Access Compliance Report

Public Rights-of-Way

Intersection ID: 19374	Main Street: SHARON_RD	Cross Street: RED_FOX_TL	Location: SE
ADA ID: E9903666E106	Ramp Type: PerpDiag	Initial Pass/Fail: Fail	Overall Compliance: No
Severity Score: 8.75			
Codes/Mitigation Info/Possible Solution		Field Measurements/Component Compliance

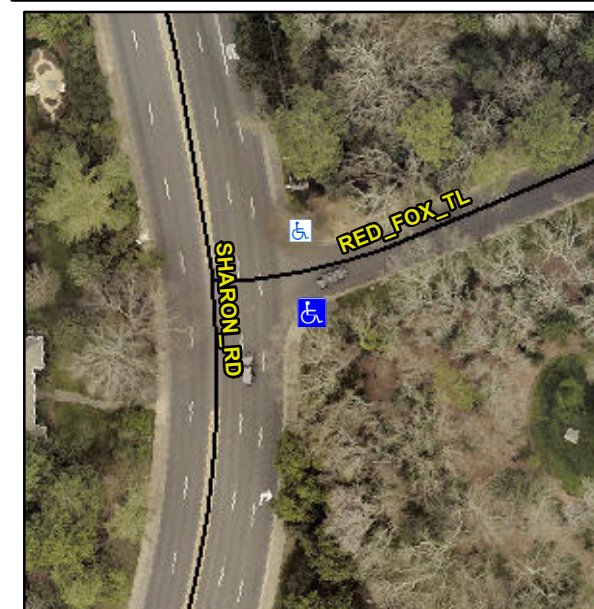
Compliance	Description	Data	Compliance	Description	Data
N/A	Ramp Length (in)	59.0	Yes	Ramp Slope (%)	7.6
No	Ramp Width (in)	40.0	Yes	Ramp XSlope (%)	0.6
N/A	Flare Type LT	N/A	N/A	Flare Type RT	N/A
N/A	Flare Slope LT (%)	N/A	N/A	Flare Slope RT (%)	N/A
N/A	Flare Traversable LT?	N/A	N/A	Flare Traversable RT?	N/A
N/A	Landing Length (in)	N/A	N/A	DWS Provided?	N/A
N/A	Landing Width (in)	N/A	N/A	DWS Contrast?	N/A
N/A	Landing Slope (%)	N/A	N/A	DWS Length (in)	N/A
N/A	Landing X Slope (%)	N/A	N/A	DWS Full Width?	N/A
N/A	Landing Curb? (Y/N)	N/A	N/A	DWS Offset (in)	N/A
N/A	Shared Landing?	N/A			
N/A	Gutter Ponding?	N/A	N/A	Gutter Slope (%)	N/A
N/A	Gutter Lip Ht (in)	N/A	N/A	Gutter X Slope (%)	N/A
N/A	Painted X Walk1?	No	N/A	Painted X Walk2?	No
	X Walk 1 Direction	To N		X Walk 2 Direction	To W
N/A	X Walk 1 Width (in)	N/A	N/A	X Walk 2 Width (in)	N/A
	X Walk 1 Slope (%)	2.8		X Walk 2 Slope (%)	0.1
	X Walk 1 X Slope (%)	0.3		X Walk 2 X Slope (%)	2.1

N/A	Ramp inside XWalk1?	N/A	N/A	Ramp inside XWalk2?	N/A
	Road Slope (%)	1.7	N/A	Clear Space?	N/A
	Road X Slope (%)	3.3	N/A	Clear Space to XWalk (in)	N/A
N/A	Any Obstructions?	N/A	N/A	Storm Grate/Utility Hazard?	N/A
	Obstruction Type			Storm Grate/Utility Type	
		N/A			N/A
		Yes		Surface Condition? (G/P)	Good

Remove & Replace Curb Ramp With Two New Directional Ramps or Equivalent.

R304.5.1
